MUNICIPAL CORPORATION,
KARACHI.

Reference No. L. C. P. 44/39.

With reference to your application dated 9th ~~an amendment~~ October 1939
with a plan for the ~~proposed~~ buildings/additions and alterations on plot
No. 103, Survey Sheet No. M.M.6, Machi Miani Quarter,
I have to request you to comply with the following requirements—

AMENDED PLAN SHOWING PROPOSED BUILDING ON
PL. of No 103 M.M.6. MACHI MIRREE QUARTER.
SCALE 8"=1"

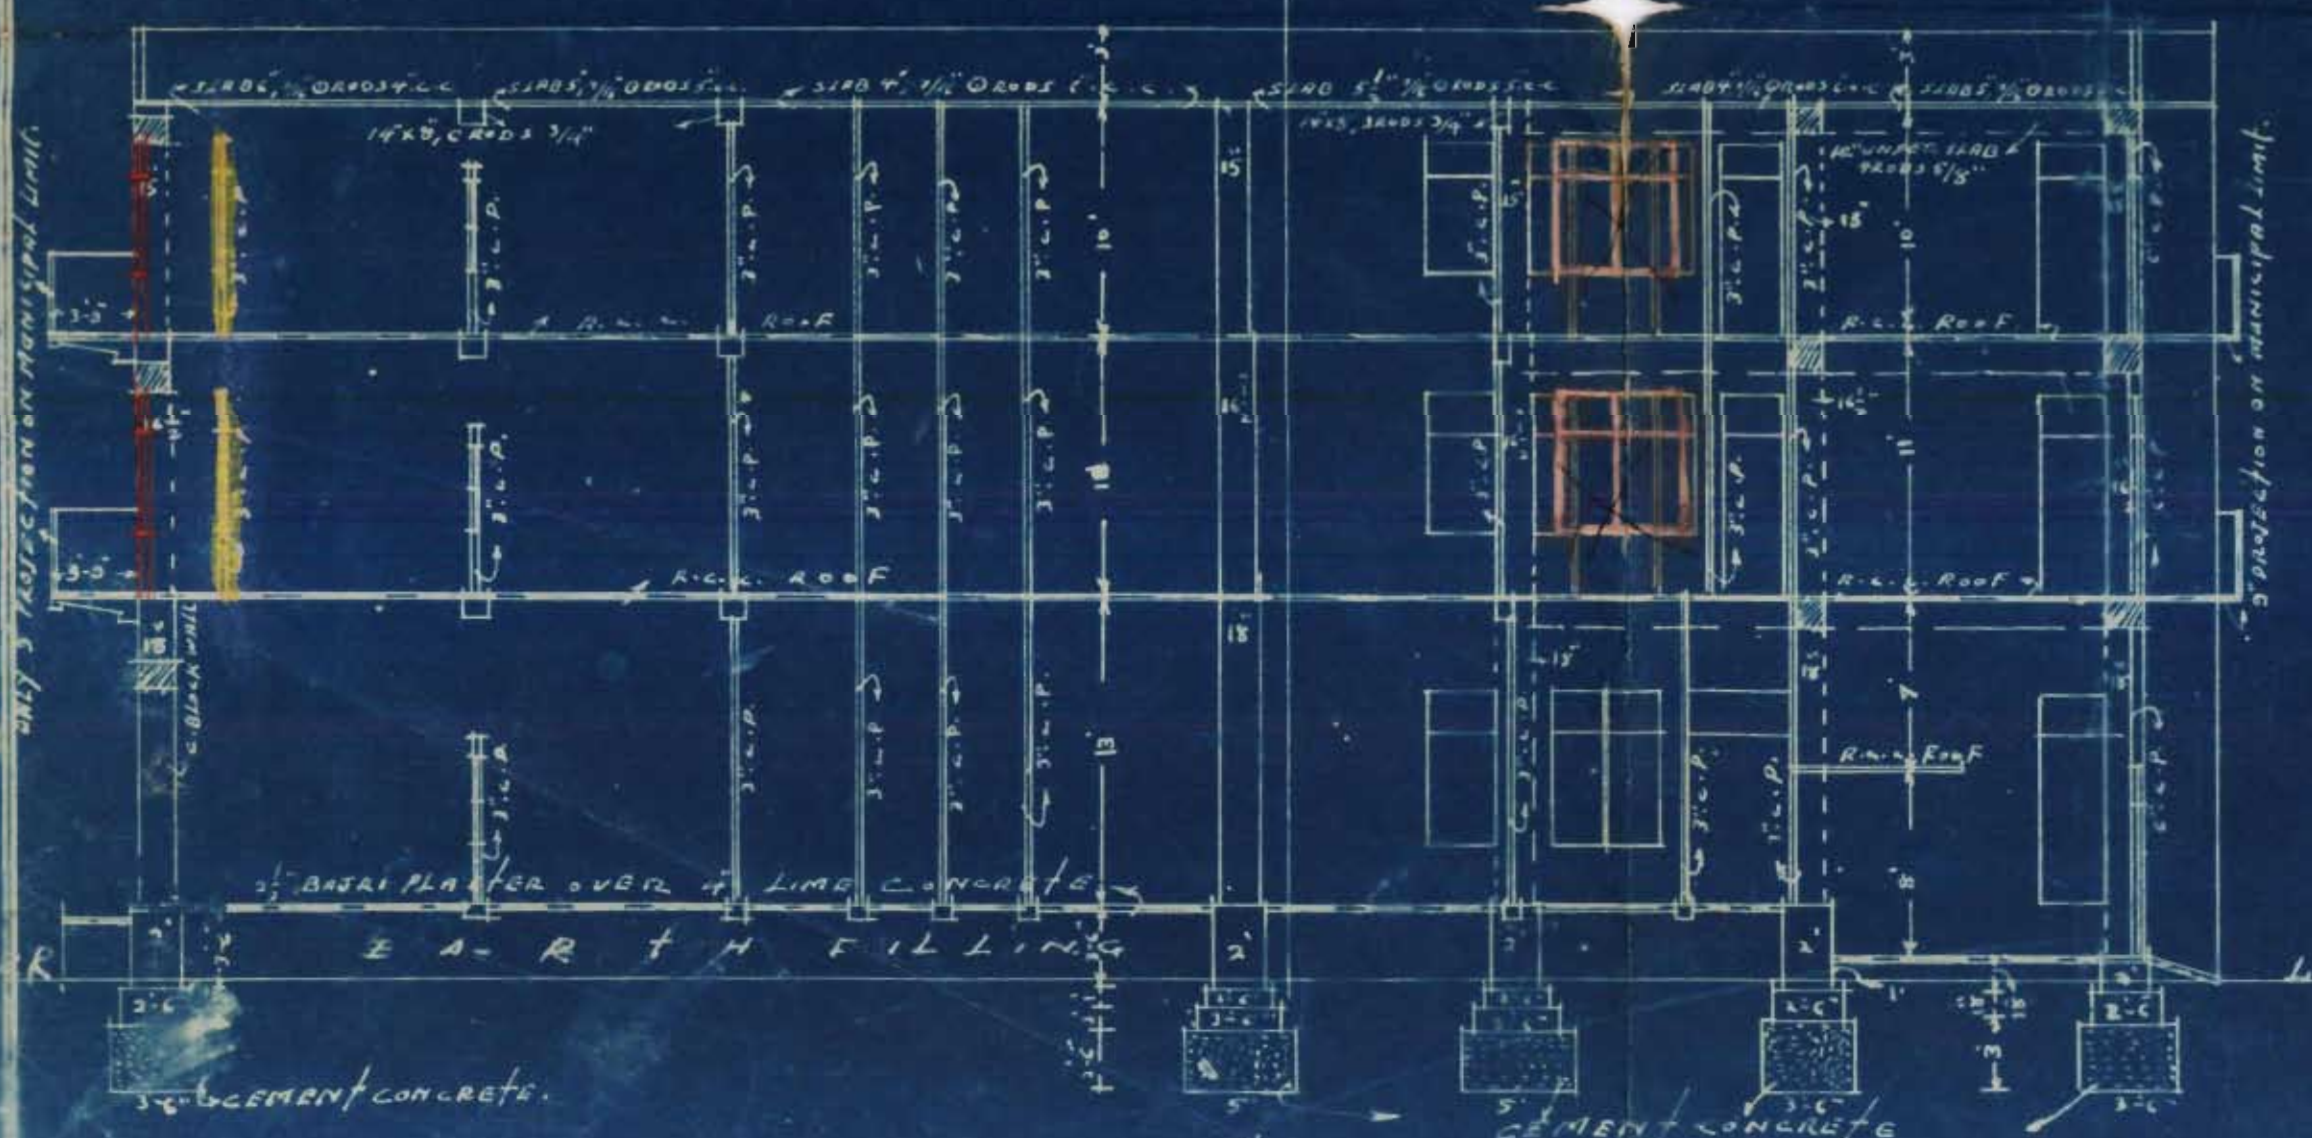
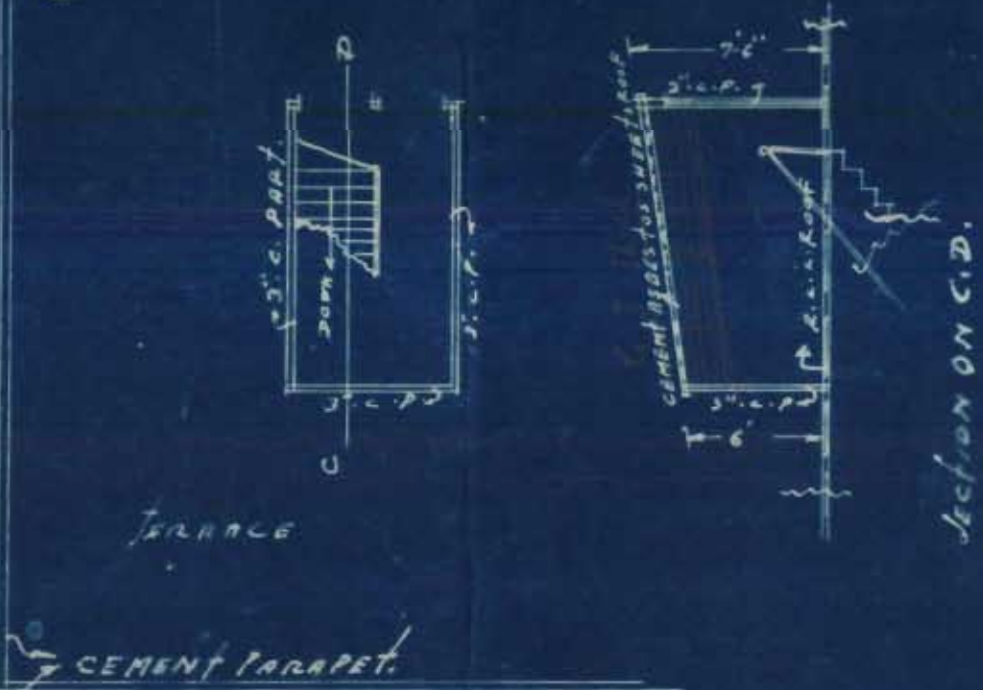
1. The soil pipes of w.c. should abut against external wall.
The proposed verandah and room will make the existing w.cs.
against rules.
2. W.cs adjoining proposed living rooms will be against rules.

3. It is not understood why a bath 21'x13" is required
4. The so called verandah on upper floors over the bath
mentioned ~~in~~ (3) is a small room which is against the
rules.
5. Dimensions of the rooms though increased by adding
verandahs are not changed in the plan submitted.
6. Section requires correction.
7. Windows be provided to the W.c.s towards the open to
sky spaces as required under the rules.
8. Built up area calculations be correctly given as per
detail plan. Measurements of built up area and open area
have to be jointly verified for which the Architect
should keep an appointment with the Building Surveyor.
9. Distances between every two balconies be given on the
plan.
- 10 All deletions to be coloured yellow.
- 11 Pillars encroaching on the open to sky space will be
taken in built up area.

Sub-Engineer's objections Nos. 1
& 2 are complied with as per his note
on the objection memo sent herewith .
L.M. & A's Objections.
No. 3.

The big bath 21' x 13' has been
kept for the common use of all the
tenants .

No. 4. Verandah was shown by mistake.
It is intended for the purpose of a
dressing room, as shown now .

Nos. 5, 6 & 7. have been complied with.

BLOCK PLAN SHOWING DETAIL OF OPEN AREA ON Plot No. 103. M.M.6
SCALE 10"=1"

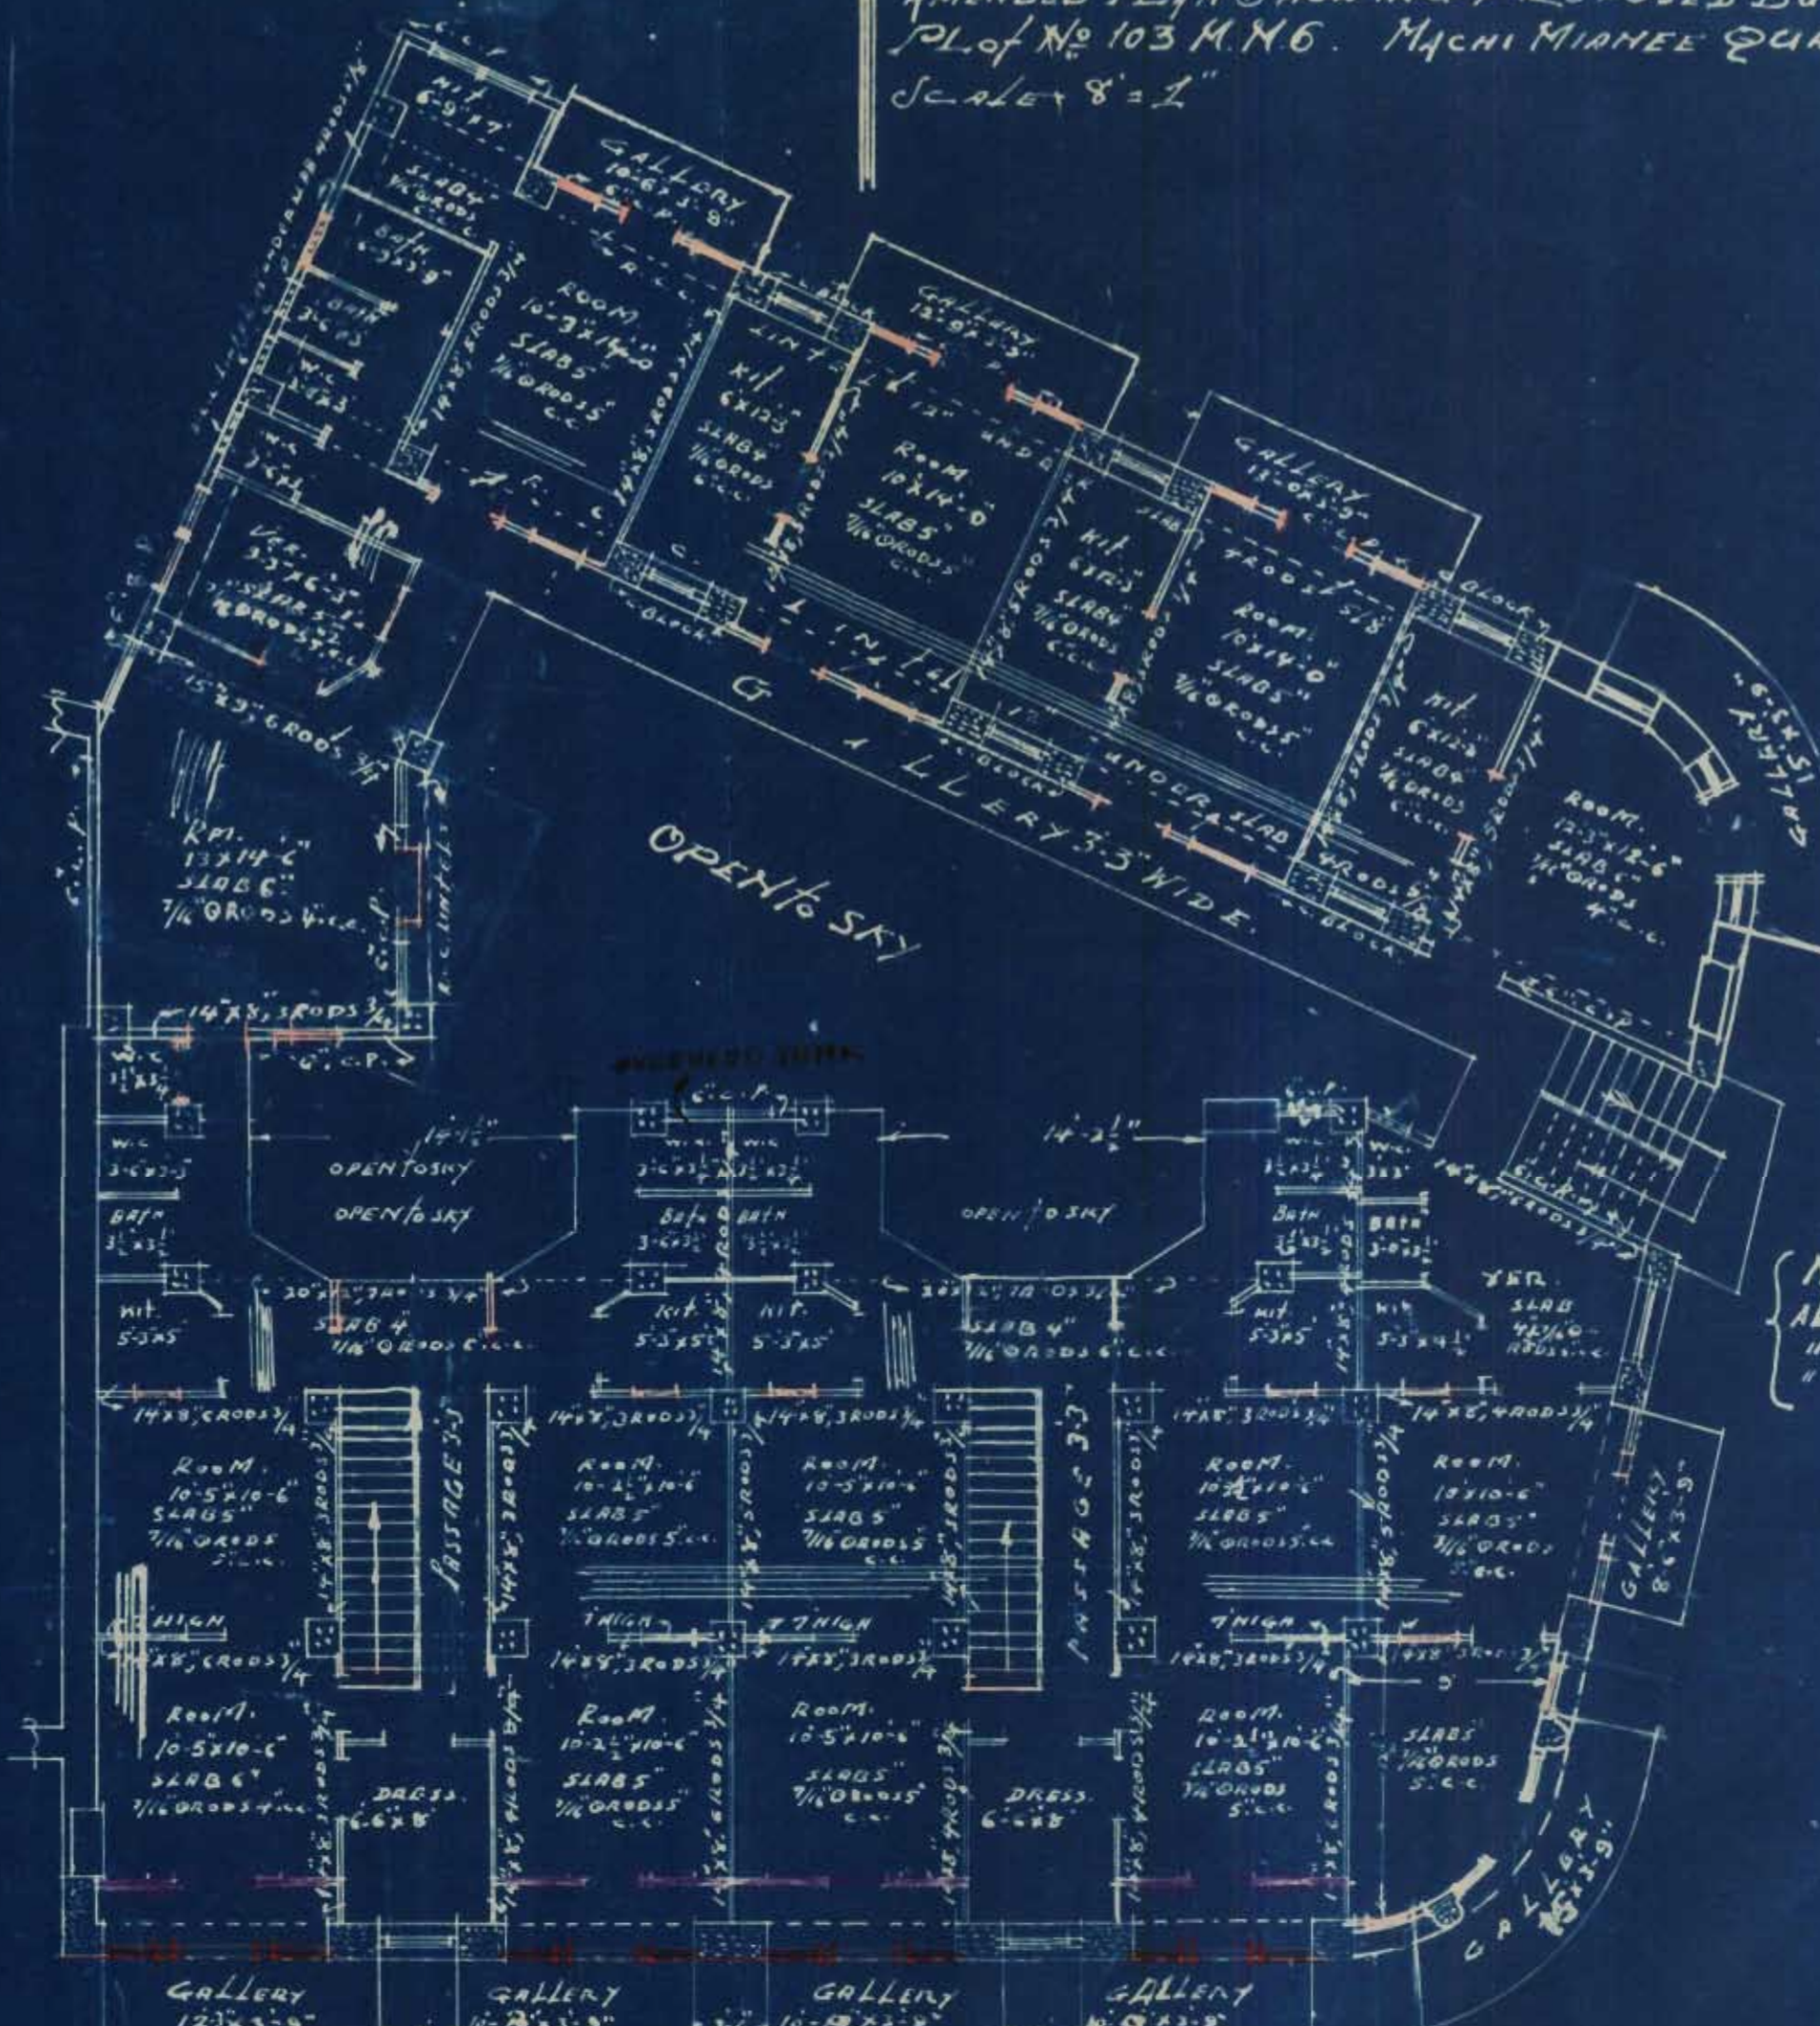
1) The built up area calculations
along with sketch as per ground measurements
taken by the architect along with BS
be sent and the built up area should
not exceed the allowable.

2) The wall in front of stairs which
is taken in open area be removed
otherwise the stairs will be taken in
built up area.

AMENDED PLAN SHOWING PROPOSED BUILDING ON
PL. of No 103 M.M.6. MACHI MIANEE QUARTER.
SCALE 8"=1"

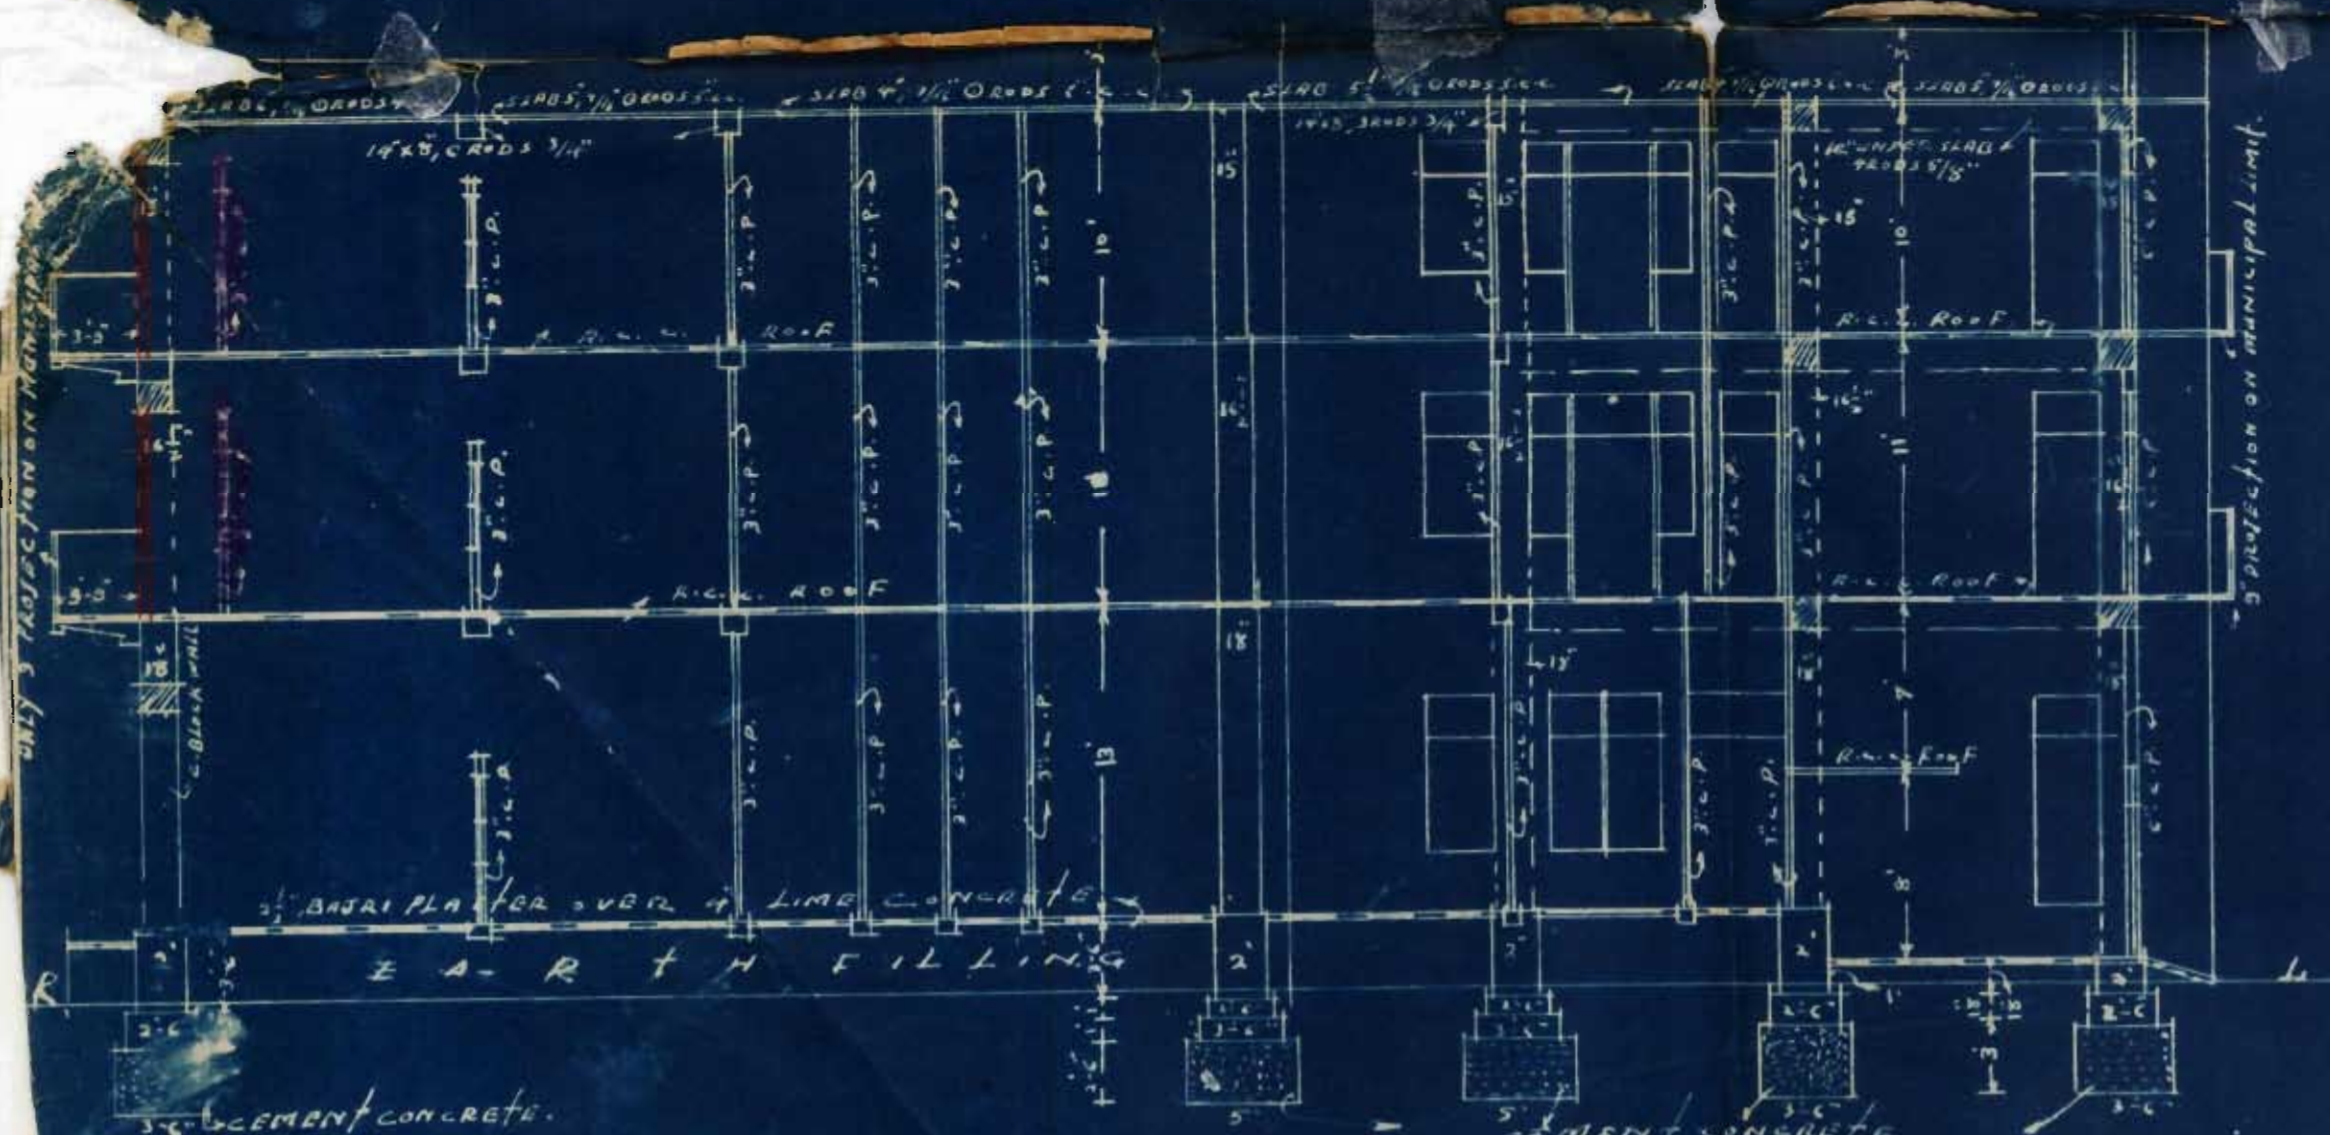
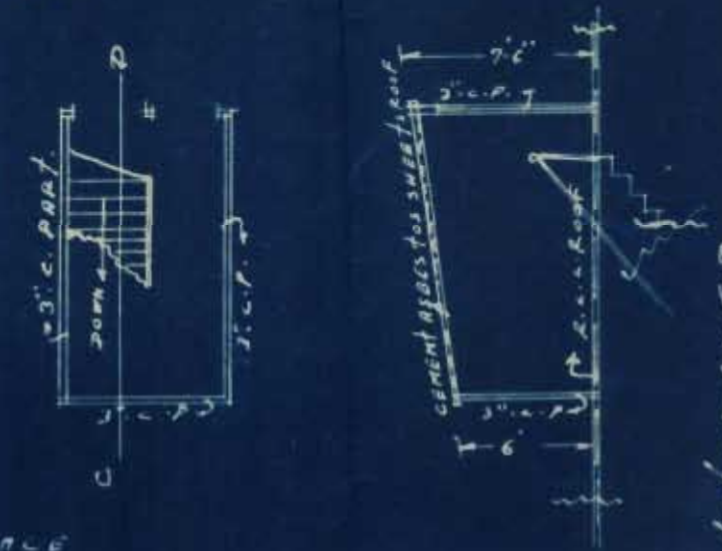
1. Built up area calculations along with sketch
 as per joint to measurements taken by the
 Architect along with Building Surveyor to be sent
 and the built up area should not exceed
 the allowable.

2. The wall in front of stairs which is taken as
 open area be removed, other wise the same
 be taken as built up area.

3. There is construction of pump room, which is not
 shown in the plan. Such big pump room can
 not be allowed in the open area.

4. The plans be corrected as per structures
 on site.
 5. The enclosure walls to be shown in the
 plan.

Complied with

Complied with
